# Access Compliance Report

## Public Rights-of-Way

### (Curb Ramps)

Intersection ID: 12863	Main Street: E_3RD_ST	Cross Street: S_CALDWELL_ST	Location: NE
ADA ID: E82A4AC99D3C	Ramp Type: Perp	Initial Pass/Fail: Fail	Overall Compliance: No
Severity Score: 26.25			
Codes/Mitigation Info/Possible Solution		Field Measurements/Component Compliance

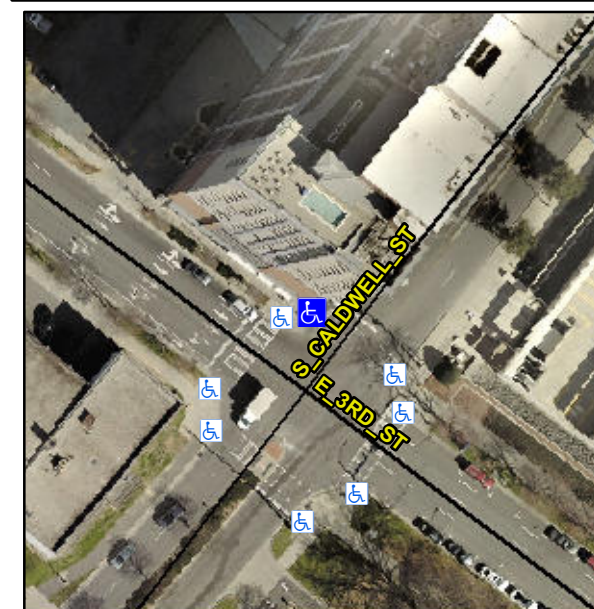
**Remove & Replace Entire Ramp.**

**R304.2.2**

Compliance	Description	Data	Compliance	Description	Data
N/A	Ramp Length (in)	80.0	No	Ramp Slope (%)	13.3
Yes	Ramp Width (in)	48.0	Yes	Ramp XSlope (%)	3.0
N/A	Flare Type LT	N/A	N/A	Flare Type RT	N/A
N/A	Flare Slope LT (%)	N/A	N/A	Flare Slope RT (%)	N/A
N/A	Flare Traversable LT?	N/A	N/A	Flare Traversable RT?	N/A
N/A	Landing Length (in)	N/A	N/A	DWS Provided?	N/A
N/A	Landing Width (in)	N/A	N/A	DWS Contrast?	N/A
N/A	Landing Slope (%)	N/A	N/A	DWS Length (in)	N/A
N/A	Landing X Slope (%)	N/A	N/A	DWS Full Width?	N/A
N/A	Landing Curb? (Y/N)	N/A	N/A	DWS Offset (in)	N/A
N/A	Shared Landing?	N/A			
N/A	Gutter Ponding?	N/A	N/A	Gutter Slope (%)	N/A
N/A	Gutter Lip Ht (in)	N/A	N/A	Gutter X Slope (%)	N/A
N/A	Painted X Walk1?	Yes	N/A	Painted X Walk2?	N/A
	X Walk 1 Direction	To SE		X Walk 2 Direction	N/A
N/A	X Walk 1 Width (in)	122.0	N/A	X Walk 2 Width (in)	N/A
	X Walk 1 Slope (%)	0.6		X Walk 2 Slope (%)	N/A
	X Walk 1 X Slope (%)	3.6		X Walk 2 X Slope (%)	N/A
